# HOWARD UNIVERSITY

**SUBJECT: AMEND LICENSE 08-00386-19  
TO REMOVE RADIOACTIVE WASTE  
STORAGE FACILITY COLLEGE  
STREET 510 – ADDITIONAL  
INFORMATION REQUESTED 6/18/12**

#### Close-Out Survey Report for Radioactive Waste Storage Facility 510 College Street

**Figure 1** Diagram of 510 College Street

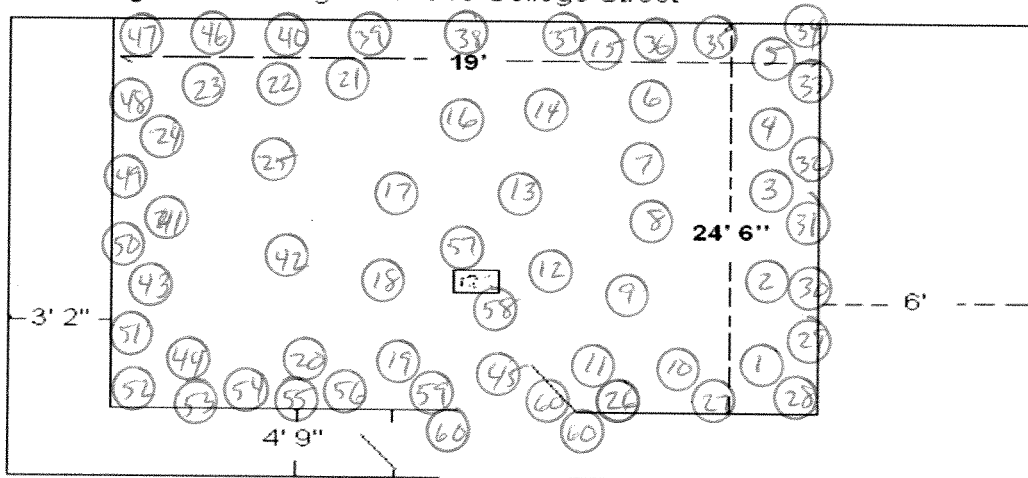
1.
  - a. Please explain what the actual dimensions of the room are, and explain what the dimensions in Figure 1 refer to, if they are not the dimensions of the waste storage area.

- b. Please use diagrams that show the dimensions of the room more accurately, with the location of survey points.

We re-measured the room area inside the waste facility. The actual dimension is about 24.5 ft. by 19 ft. (~465.5 ft. <sup>2</sup>).

Please see attached
